# Final DD Report

## RP7 Price Control Engineering Support & Asset Management Advice

Utility Regulator for Northern Ireland

23 October 2023

**Figure 2 Comparison of Model Outputs - 33kV Replacement Volumes**

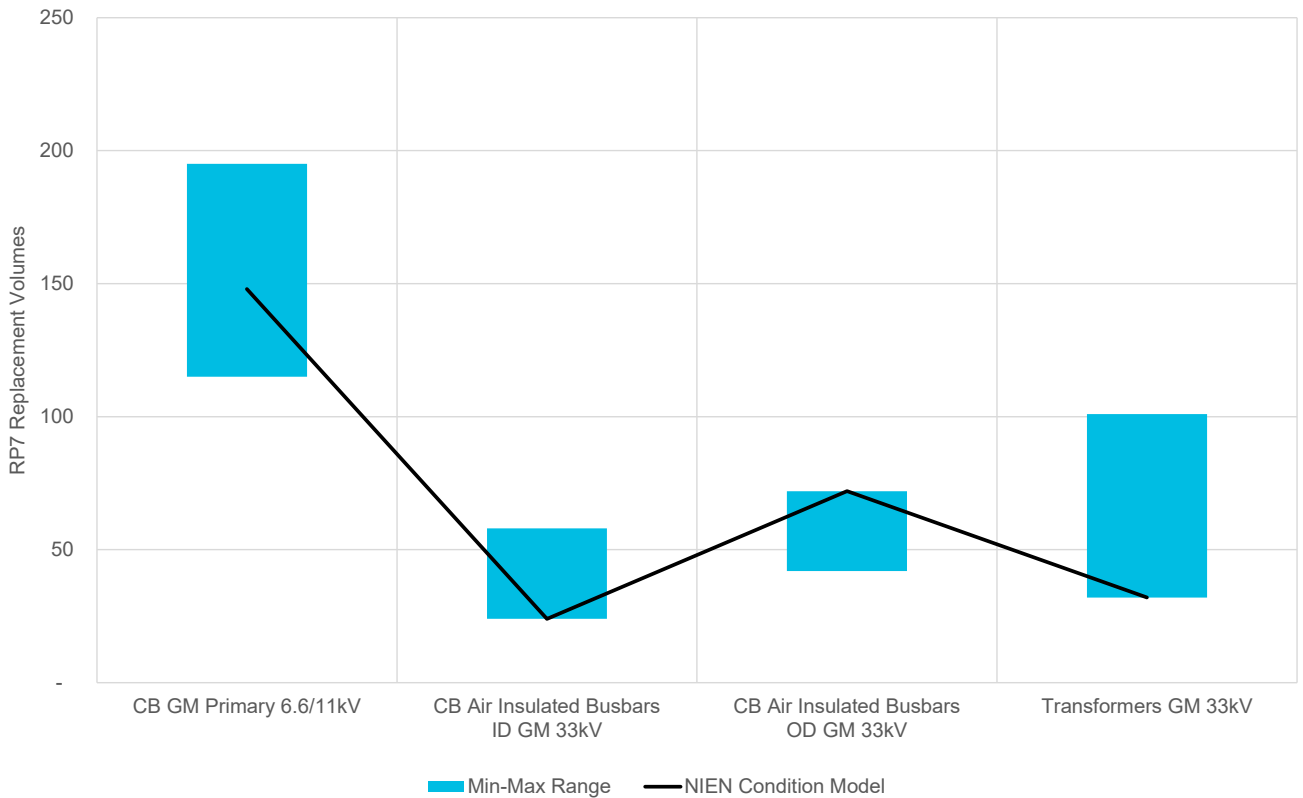
For the 33kV Outdoor CB replacement volume, the NIE Network condition-based model produces the highest replacement volumes for RP7. This higher volume is driven by a specific type-defect (SWS EO1 type), described above for which NIE Networks has investigated repair options for the oil filled 33kV circuit breaker but with no viable solution being identified. We remain satisfied that the replacement volumes for these asset categories are reasonable for RP7.

Figure 3 Distribution Primary plant – Unit cost assessment

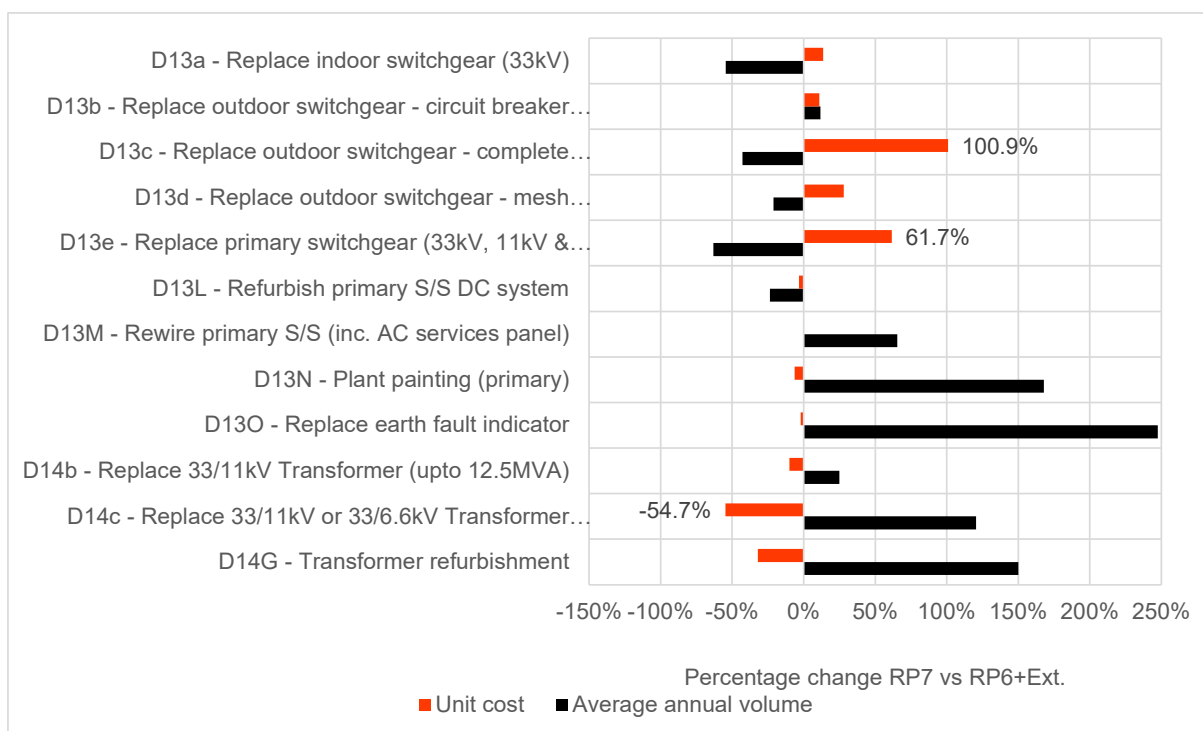
From Figure 3 it is evident that the requested unit costs for the D13c and D13e expenditure categories correspond to the greatest percentage changes. In addition, NIE Networks’ query response on unit costs<sup>12</sup> indicates the assessment carried out by NIE Networks to apply adjustments to the March 2022 outturn unit rates. These comprise adjustments to account for:

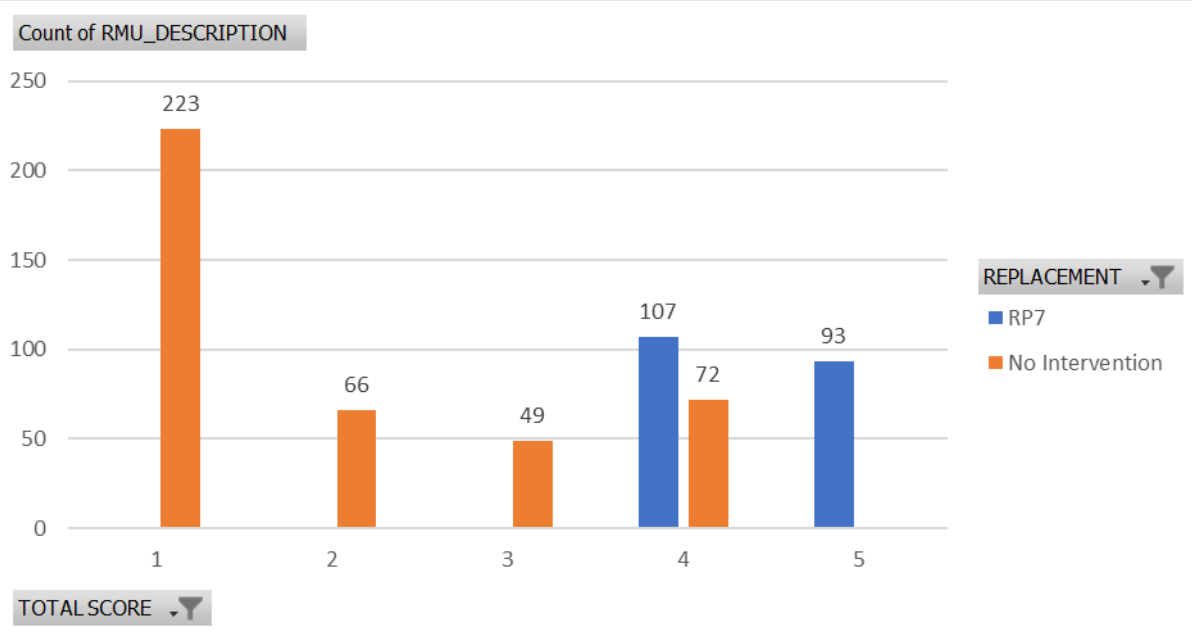
It was noted that there were 9 substations with the G.E.C. SATURN RT 11KV SF6 type RMU that had been included in both the D15a and D15b plans for intervention, indicating that they had been double counted in the volumes.

**Figure 4 Comparison of Model Outputs - 11kV & LV Asset Replacement Volumes**

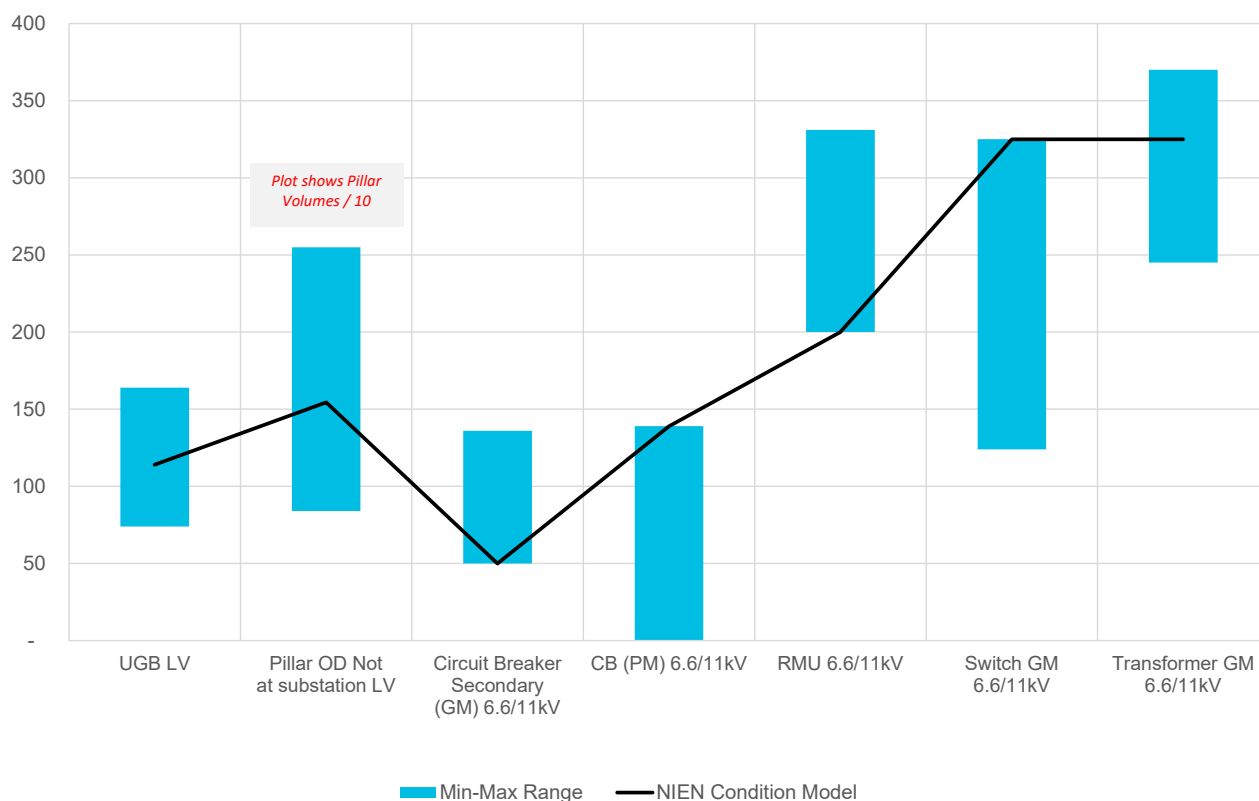
For the 11kV pole mounted CB replacement volumes (Sectionaliser replacement), the recommended RP7 volumes are based on intervention required to address an identified type defect with the SF6 units resulting in loss of SF6 gas.

For the 11kV ground-mounted switch replacement volumes, the replacement volumes are included within the work programme for complete substation replacement. The prioritisation of these replacement works is based on detailed condition-based assessment for the NIE Networks distribution substation portfolio, which the age-based survivor model would not factor into the calculation of replacement volumes. We remain satisfied that the replacement volumes for these asset categories are reasonable for RP7.

Figure 5 Distribution Secondary plant – Unit cost assessment

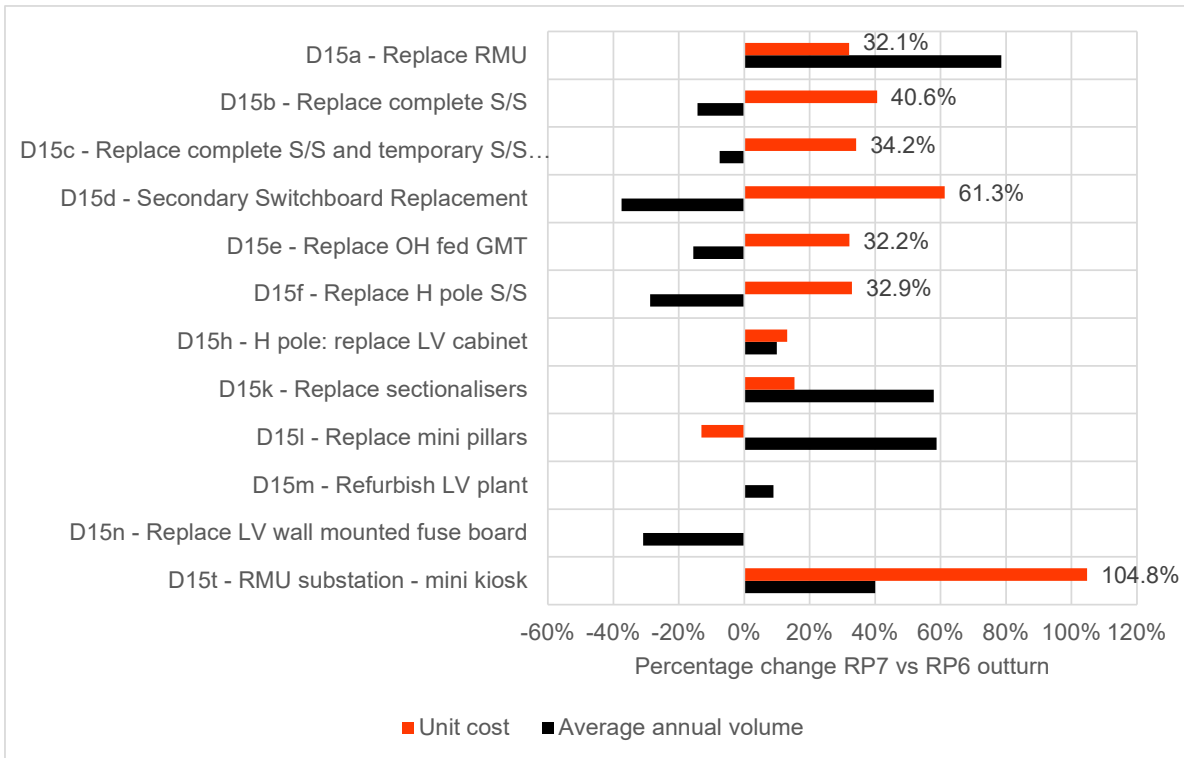
From Figure 5, it can be seen that 7 categories observed unit cost increases, when comparing RP6 outturn to RP7 that were greater than 20%, the largest increase being associated with RMU substation mini-kiosk replacements.

**Figure 6** Distribution protection – Condition assessment summary for 33kV sites (retrofit)

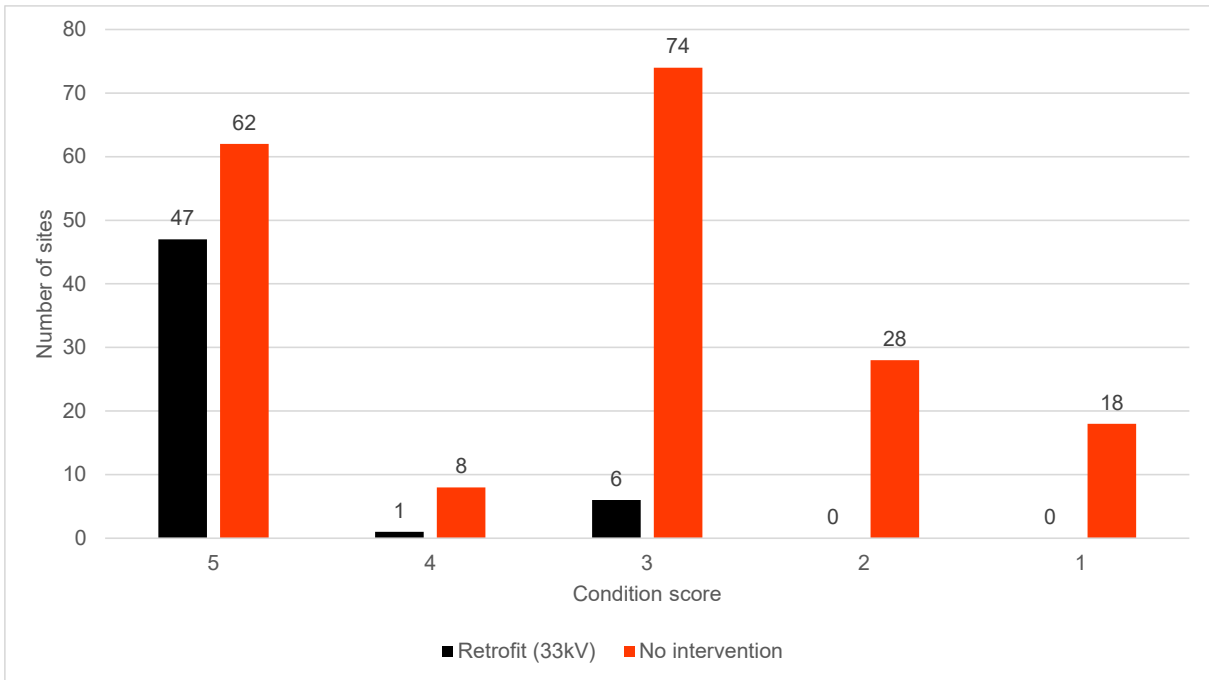
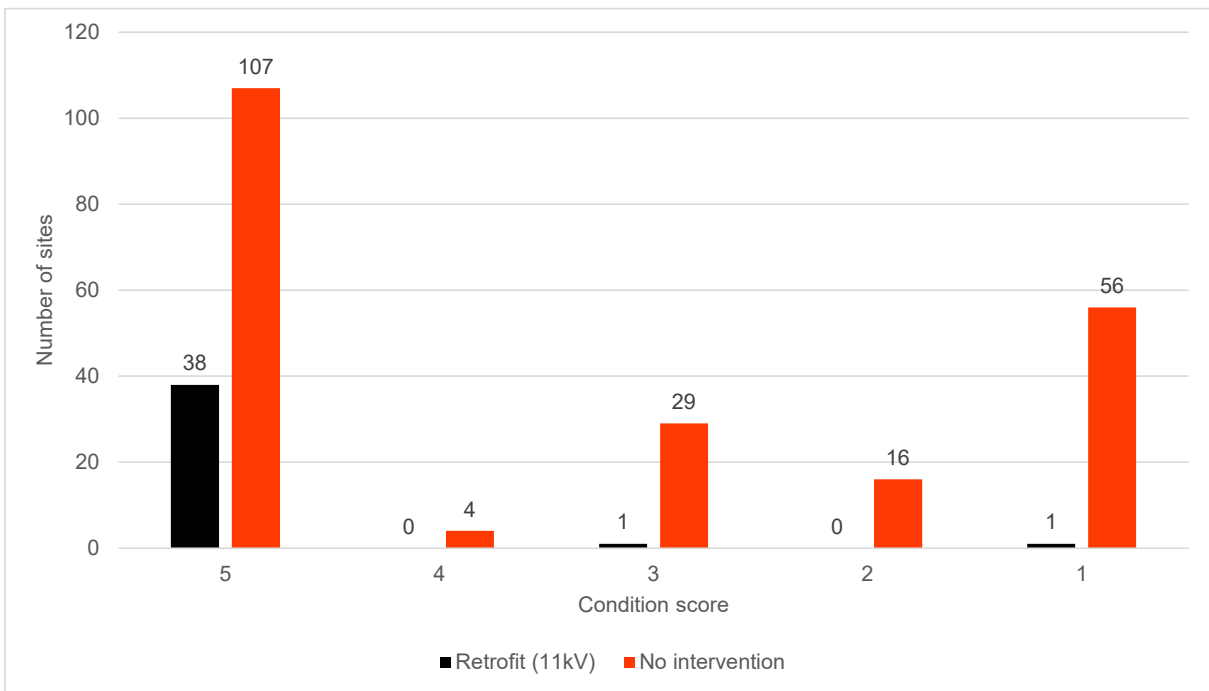
The results shown in Figure 6 and Figure 7 indicate a high population of sites where equipment has been assigned a score of 5 (immediate intervention required).
